Town of Randolph
Powers Farm Community Park and Bertha Soule Memorial Park

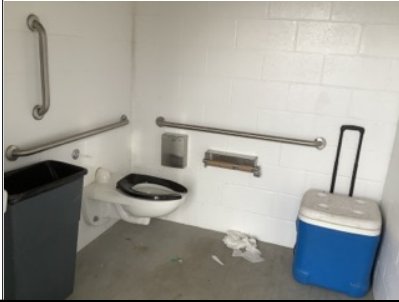
ID	Location	Floor	Room	Element	Type	Photo	Issues	Current Measure	Recommendations	Quantity	Price	Cost Estimation
Approach and Entrance												
Exterior Access Route												
1	Powers Farm Trail to Bertha Soule Memorial Park Trail	Ext.		Exterior Access Route	Exterior		Exterior route < 48" wide	42"	Ensure that a clear width of 48" min. is maintained at the accessible route.	1	-	\$0
2	To Play Area From Toilet Rooms	Ext.		Exterior Access Route	Exterior		Surface openings > 1/2" Level changes > 1/4"	1.5" 2"	Repair surface so that openings are 1/2" max. Alter the change in level to be 1/4" high max. Recommendation applies to all entrances to the play area.	1	-	\$0
3	Bench Along Powers Farm Trails	Ext.		Exterior Access Route			Does not prevent accumulation of water	-	Repair the surface.	1	-	\$0
Off-Street Parking Lot or Garage												
4	Parking Lot	Ext.		Off-Street Parking Lot or Garage	Visitor		Total # of parking Total # of designated accessible parking spaces Total # of designated van accessible spaces Access aisle not provided Sign not provided	33 0 1 - -	Provide a car accessible space 96" wide min. with a marked access aisle 60" wide min. At the car accessible space, include a sign with the International Symbol of Accessibility (ISA). At the van accessible space, include a sign with the designation "Van Accessible", with the bottom of the sign 60" min. above the ground and the top 96" max. above the ground.	2	-	\$0
